SERVICE BULLETIN

Subject: Frameworkx Tel-E-Foul Cover Lens Improvement

Bulletin No. SB10-4

Figure 1

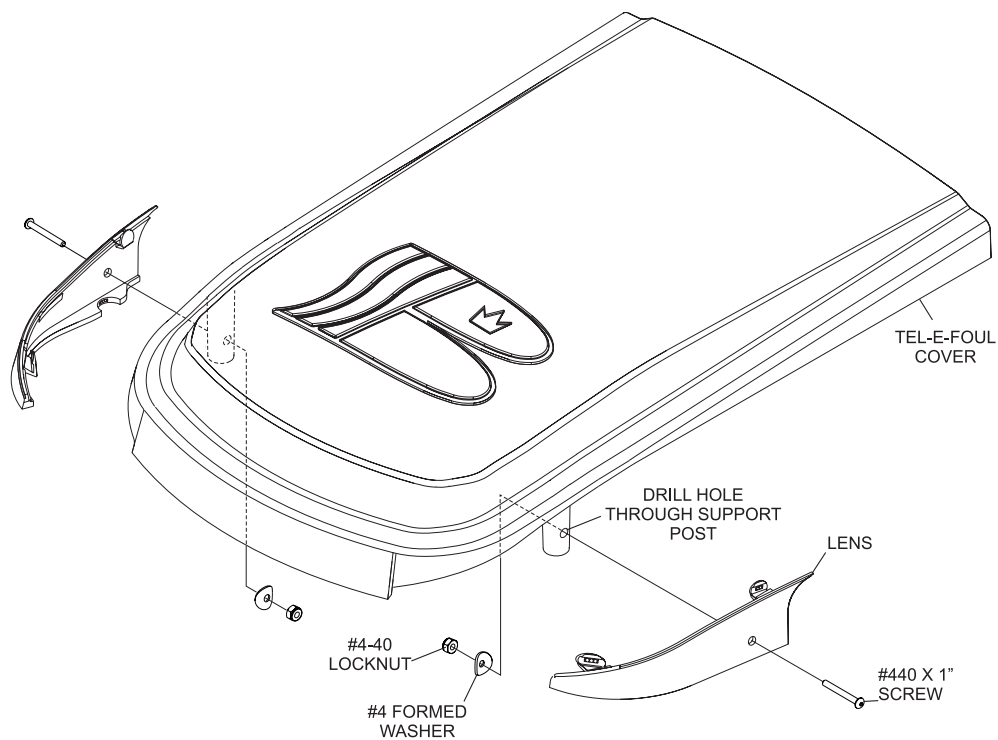
We are pleased to announce the release of a more robust mounting system for the Frameworkx Tel-E-Foul cover, red lens. The enhanced design secures the lens to the support boss for the foul light cover with a button head screw. Refer to *Figure 1*.

This design change will be implemented in all new production going forward. The cover assembly has a new part number, 84-860769-000. This replaces the old part number, 84-860603-000.
